400 W. HAZEL ST. PLAT WITH MODS

Applicant's Request: Request for a plat with modifications for the development of two single-family homes on two lots which do not meet the lot depth requirement of 110 ft.

Staff Recommendation: Approval of the Minor Plat with Modification of Standards, per the conditions in this staff report.

SITE PHOTOS

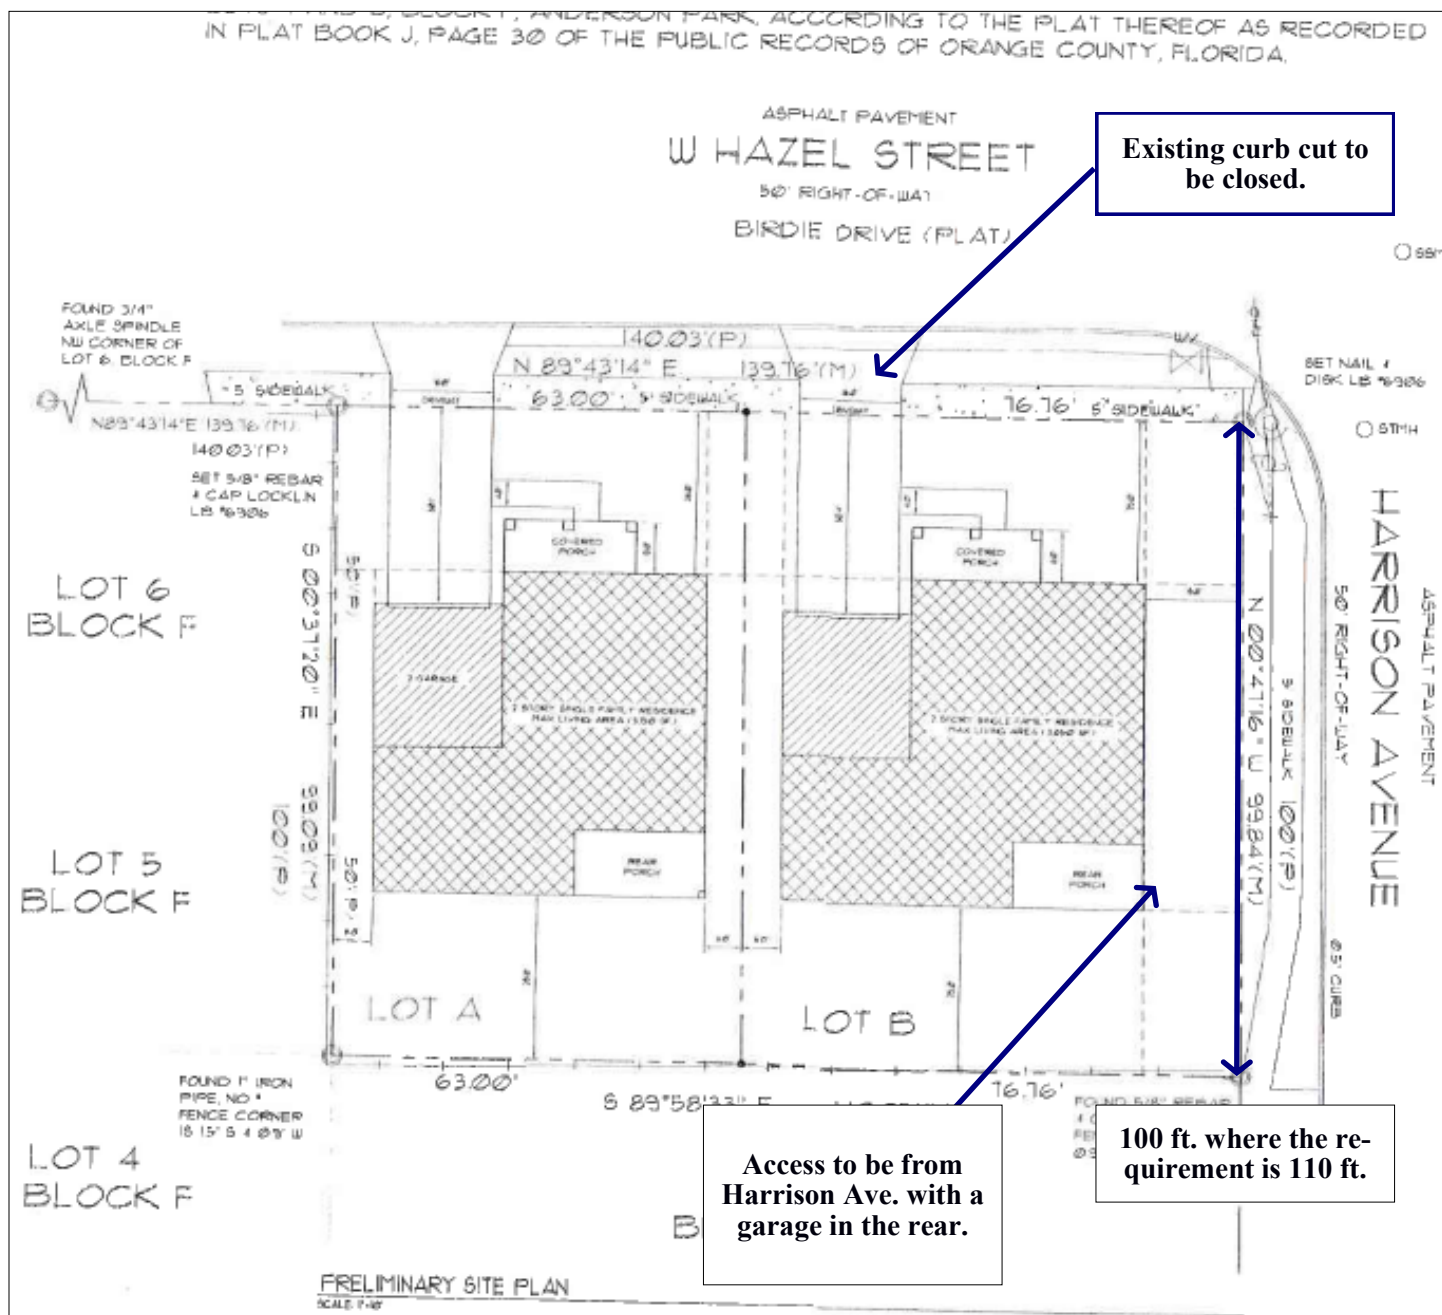
**House to be
demolished.**

**Trees in images
will be preserved
with this proposal.**
